Access Compliance Report Public Rights-of-Way (Curb Ramps)

Main Street: ROANOKE_DR		Cross Street: VINEYARD_RD		Location:	SE
ADA ID: RPAT211103111555	Ramp Type:Type 1 - Perpendicular Diagonal Initial Pass/Fail: Fail		Overall Compliance: No	Severity Score:	30

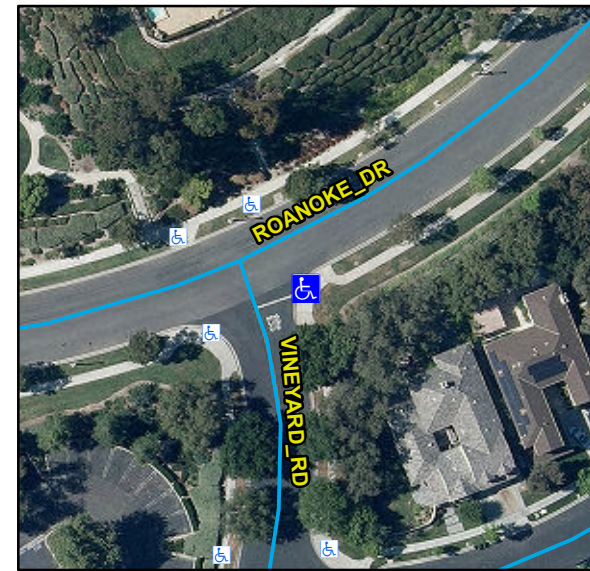
R304.2.2, R204.3, R304.5.3, STD 1115

Remove & Replace Curb Ramp With Two New Directional Ramps or Equivalent.
